Technical Service Bulletin

SUBJECT:		No: TSB-21-42A-011	
MODIFIED HOOD FOR HOOD FLUTTER - 2022 OUTLANDER		DATE: December 2021	
		MODEL: 2022 Outlander	
CIRCULATE TO:	<input type="checkbox"/> GENERAL MANAGER	<input checked="" type="checkbox"/> PARTS MANAGER	<input checked="" type="checkbox"/> TECHNICIAN
<input checked="" type="checkbox"/> SERVICE ADVISOR	<input checked="" type="checkbox"/> SERVICE MANAGER	<input checked="" type="checkbox"/> WARRANTY PROCESSOR	<input checked="" type="checkbox"/> SALES MANAGER

Image 1

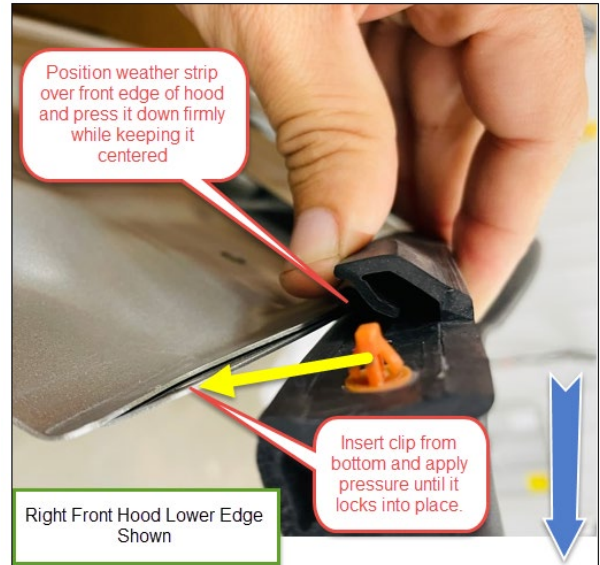
PROCEDURE FOR W/STRIP,HOOD FR END

1. Install front weather strip.
2. Install and secure grill with 11 mounting bolts (reuse grill from original hood).
